Submittal #055000-7.R2 055000 - Metal Fabrications

Project: 1386 - Signature at West Pryor
2100 NW Lowenstein Dr.
Lee's Summit, Missouri 64081

Carport Shop Drawings

RE: Summit Phase 2

COLUMN TO BEAM CONNECTION

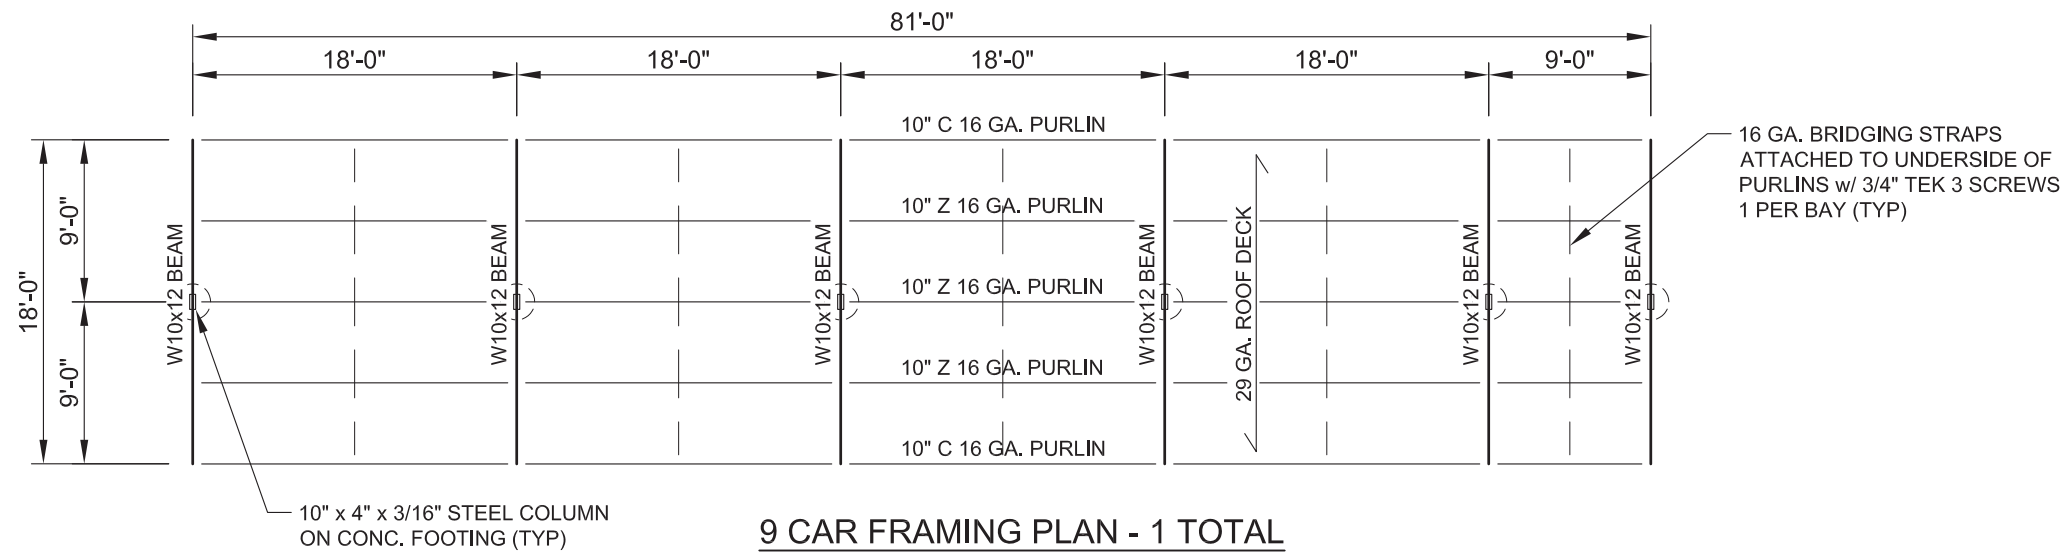
NAME	SENT DATE	DUE DATE	RETURNED DATE	RESPONSE	ATTACHMENTS	COMMENTS
General Information Attachments					055000-7-R2 Carport Shop Drawings - 3.9.23.pdf	
Clark Basinger	03/09/2023	03/10/2023	03/09/2023	Approved as Noted	055000-7-R2 Carport Shop Drawings - 3.9.23.pdf (Current)	designer should specify member connections
Michaela Silva	03/09/2023	03/13/2023		Pending
